INTERIM REPORT
HORIZONTAL TIE REPLACEMENT
STERLING TOWN HALL
STERLING, MASSACHUSETTS

Prepared by

Harvey & Tracy Associates, Inc.
143 Dewey Street
Worcester, MA 01610

August 1987

TRUSS LAYOUT PLAN

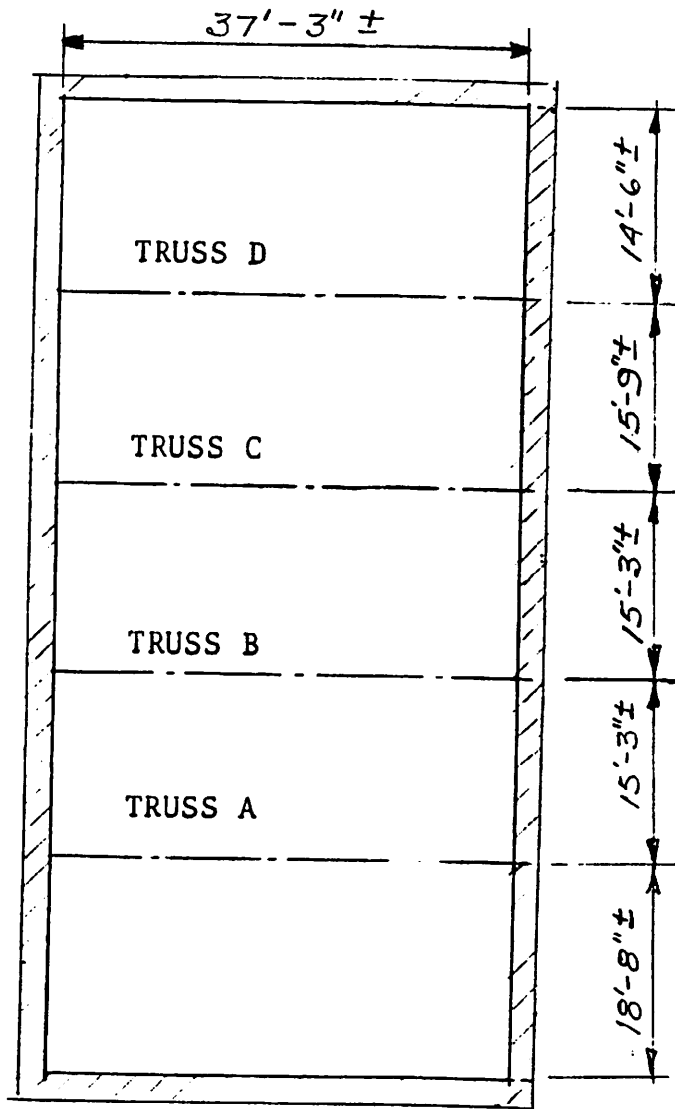
Several months ago a failure occurred in one of the ties (A)* in the original building. When the failure occurred the eave line on the two opposite sides of the building spread somewhat at this location. Although the only information concerning the failure as related to this office is verbal, it appears that the failure occurred in the connection of the yoke device to the rod at one of the two ends.

This rod assembly was then replaced with a cable type of assembly while still utilizing the existing yokes at the ends. Sometime later a similar type of failure occurred at the second tie (B)* within the original portion of the building. This one was then repaired in a similar fashion and it was then the intent of the Town to replace the ties (C and D)* which were in the newer portion of the building. After tie (C) had been replaced Harvey & Tracy Associates, Inc. was contacted to review the repairs that were being and had been undertaken and to comment on their appropriateness.

The yoke type devices at the end of the ties (A and B)* in the original part of the building had undergone some distortion as might be expected as their configuration introduced forces and stresses that were not designed for. This distortion in turn caused distress in the wood members to which they are attached.

There does not appear to be any distress in the remaining tie (D)* in the building addition. A visual review in the attic (limited because of low head room) indicated that there were cracks in some of the wood framing components of the roof.

The pieces of the original tie rod assemblies (A and B)* which had failed were discarded when the replacement ties were installed. Therefore, it is impossible to determine precisely what the mode of failure was. Because the two failures occurred at different times it is also impossible to ascertain what type of loading the building may have been subjected to at the time those failures did take place.

The replacement tie rod assemblies installed to date (A, B, and C)* do not appear to be structurally adequate for code mandated loads and in the case of ties A and B particularly because these incorporate the yoke devices described previously.

The one remaining tie rod assembly (D)* in the building addition does not at this time evidence any visible signs of distress.

New tie rod assemblies should be designed and installed to replace all of the existing tie assemblies including the ones recently installed.
